From: [REDACTED]
To: [REDACTED]
CC: [REDACTED]
Sent: 2/24/2021 7:26:26 AM
Subject: RE: O8W-PM [REDACTED] - Bucks Creek 1101 Phase 1,2&3 - Pre-Engineering Meeting

Subject: O8W-PM Meeting - Bucks Creek 1101 Phase 1,2&3 - Pre-Engineering Meeting

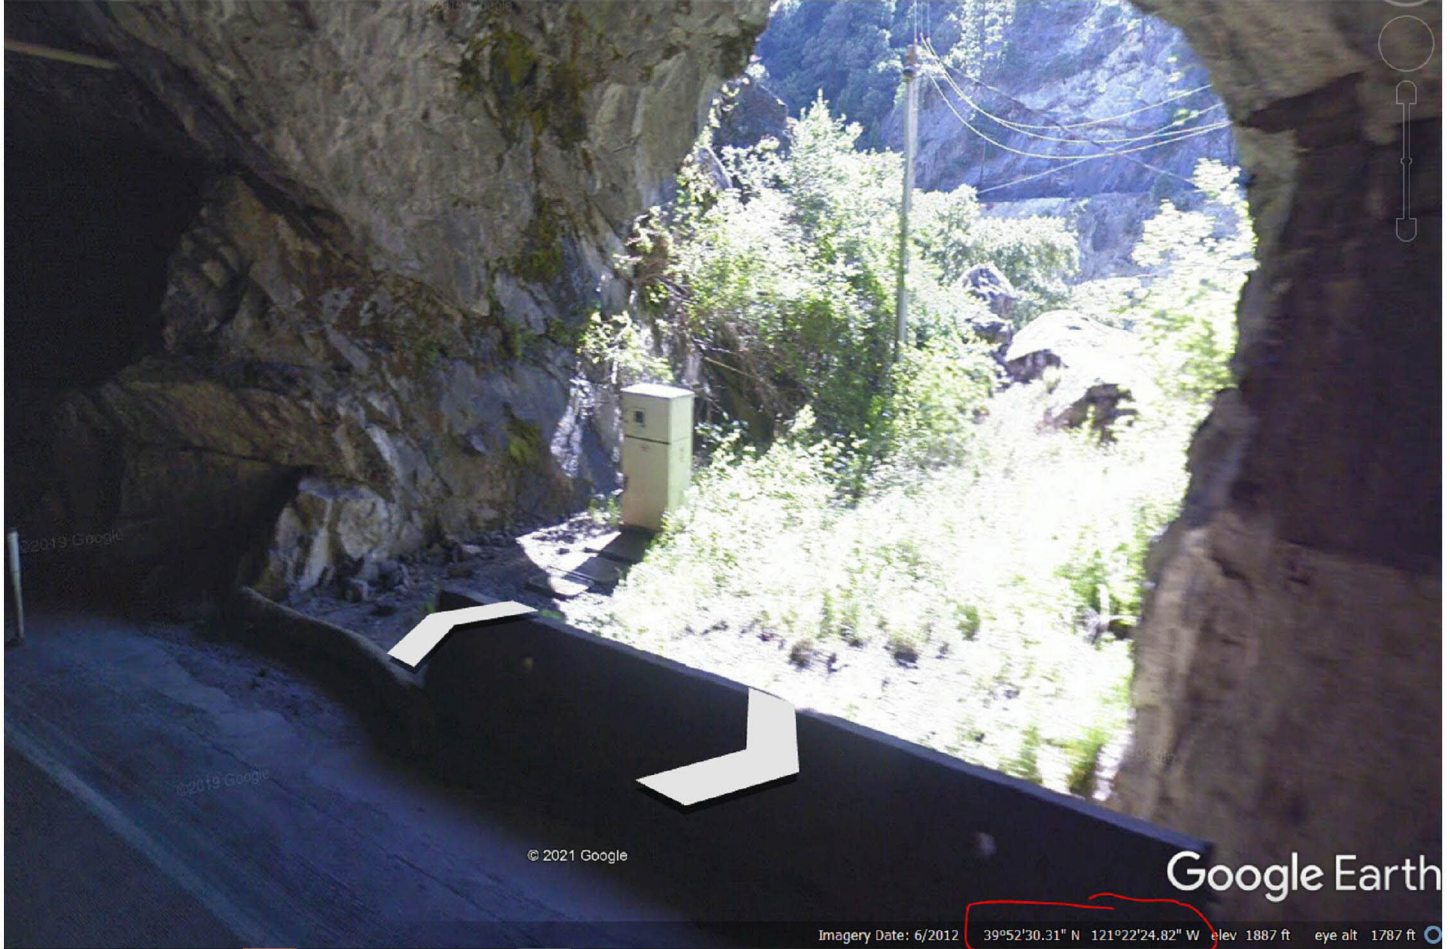
Attached are the 'base-map' limits in a kmz. file. As you will see, we need our base-map to go about ~100' into the tunnel at the south end (see pedestal in picture below....please begin about ~50 beyond this point which is about ~100' beyond the Cresta Dam).

We want to end the base-map at the sign location below which is roughly at MM (Mile Marker) 5.10.
